<b>Docket Number:</b>	17-AAER-06
<b>Project Title:</b>	Commercial and Industrial Fans & Blowers
<b>TN #:</b>	224415
<b>Document Title:</b>	Lochinvar, LLC Comments On CEC's Analysis of Efficiency Standards and Test Procedures for Commercial & Industrial Fans & Blowers
<b>Description:</b>	N/A
<b>Filer:</b>	System
<b>Organization:</b>	Lochinvar, LLC
<b>Submitter Role:</b>	Public
<b>Submission Date:</b>	8/6/2018 1:32:52 PM
<b>Docketed Date:</b>	8/6/2018

**On CEC's Analysis of Efficiency Standards and Test Procedures for  
Commercial & Industrial Fans & Blowers**

Re: Analysis of Efficiency Standards and Test Procedures for Commercial and Industrial Fans and Blowers

*Depiction of Fan Energy in Proportion to Fuel Energy in a Commercial Boiler*

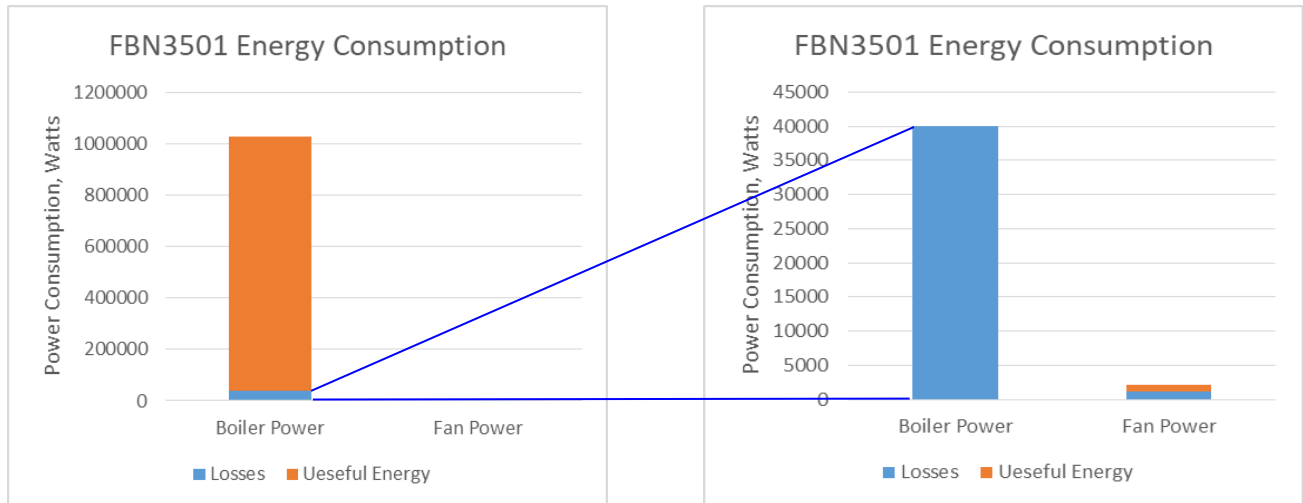
The electrical power consumption of fans used to provide air for combustion in gas fired equipment is a small fraction of the energy consumed. As an example, a 3,500,000 Btu/hr burner uses a fan with a maximum power input of 2,200 watts for combustion air supply.

The electrical power input to the combustion fan is about 0.2% of the total energy input to the burner (this is typical for combustion systems). In other words, if the fan is made 50% more efficient the fan energy savings will be 0.1% of the energy consumed by the boiler or water heater. If the limitations on fan use cause the boiler or water heater to lose more than 0.1% efficiency the net energy consumption is increased. The example is based on an actual product and is scalable, meaning that proportion of fuel energy and fan energy is a relatively constant ratio as size increases or decreases.

The inclusion of fans used for combustion air (referred to in the proposed rule as "imbedded fans") in commercial water heaters and boilers in the proposed rule is expected to increase energy consumption for the affected products and increase the cost of the affected products by at least 10%. We recommend excluding imbedded fans in water heaters, pool heaters and boilers.

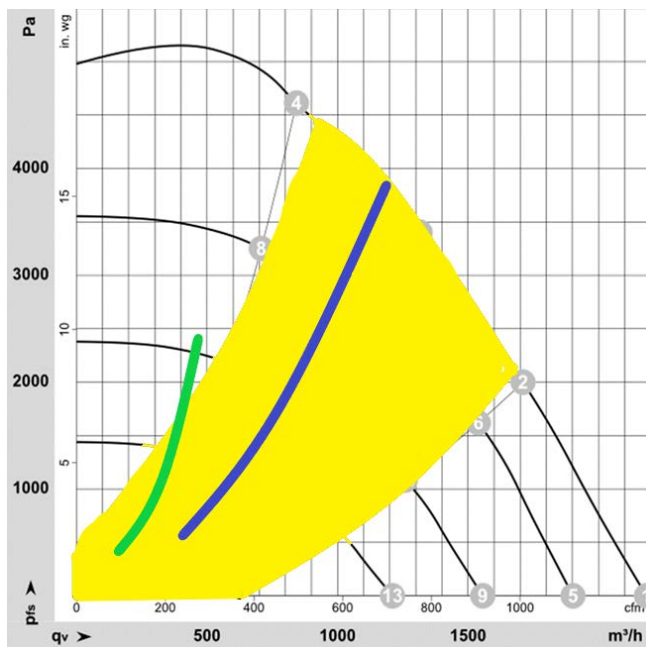
The affected fans used by Lochinvar all employ ECM motors and are high performance products. In spite of the relatively broad operating window of our combustion fans, we have determined that some of our operating conditions will fall outside the allowable fan curves. The boiler used in the example below uses an air throttling valve to allow the boiler greater turndown. The longer blue curved line shows operation with the air throttling valve open and the shorter green curve shows the operation with the throttling valve closed. All the area where the curves extend outside the shaded area show operational range that would no longer be allowed due to the proposed fan rule.

The fan rule would force us to not allow California boilers to close the air throttling valve. Although part of the green curve is within the allowable range, the point where the low operating range ignites the burner is outside the allowable window. The effect of the rule would be elimination of operation with the throttling valve closed. The revised operating range of the boiler would change from 25:1 turndown to 5:1 turndown. The loss of turndown ratio reduces the ability of the boiler to match the heating load.

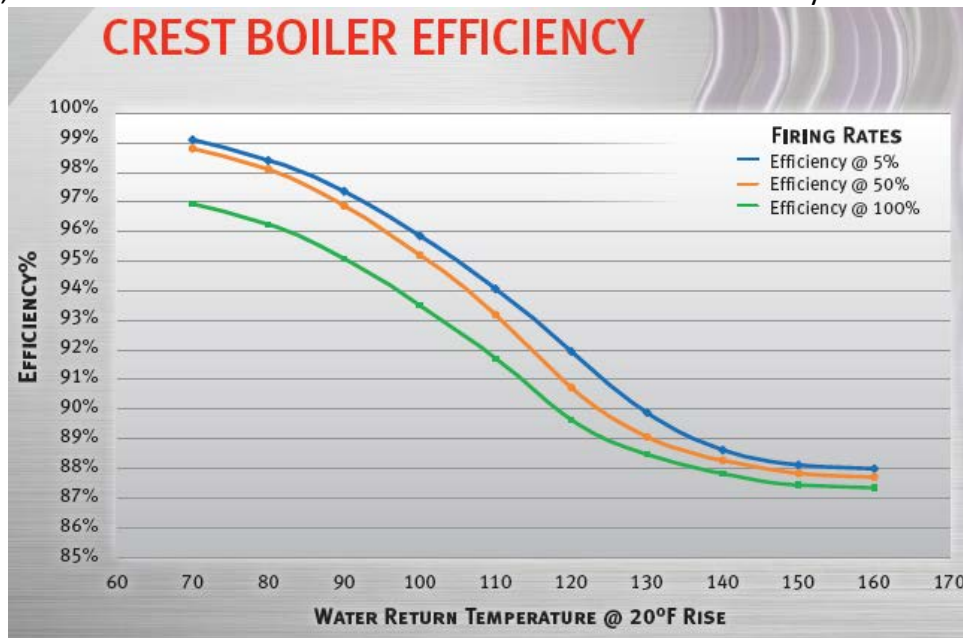
Modulation or turndown for heating products allows the unit to throttle the heat input to match the demand for heating. Matching the input to the output reduces or eliminates standby and off mode energy loss. Load matching is promoted by ASHRAE 90.1, the Consortium for Energy Efficiency (CEE) and the American Consortium for an Energy-Efficient Economy (ACEEE).<sup>1</sup> If standby losses for a heating system exceeds just 0.1% of the system input, then load matching saves more energy than the combustion fans consume.

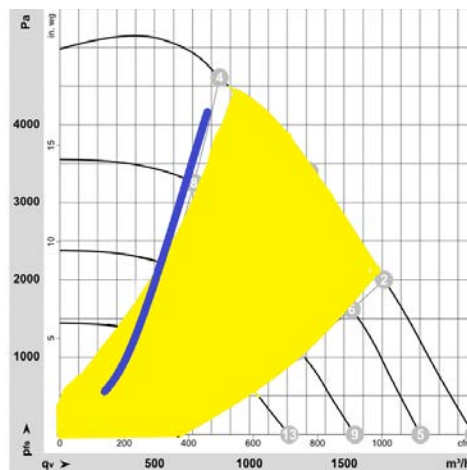
Moreover, the fan regulation could entirely eliminate some of the highest efficiency products from the California market. Boiler and water heater heat exchangers are designed to maximize surface area in contact with combustion gasses and to create turbulence in that flow. These features create a more steep resistance curve. The highest efficiency heat exchangers we offer have step curves that will go outside the allowable fan window.

These high resistance products rated at 98% thermal efficiency will not be allowed due to the fan rule, but an 85% thermal efficient product will be allowed because their curve falls within the fan's optimal efficiency. Here again, the loss of fuel efficiency vastly outweighs the possible fan efficiency gains.

Applying the proposed fan rule to combustion blowers in water heaters, pool heaters and boilers will increase energy consumption in California. Imbedded fans for boilers and water heaters should be excluded from the final rule.
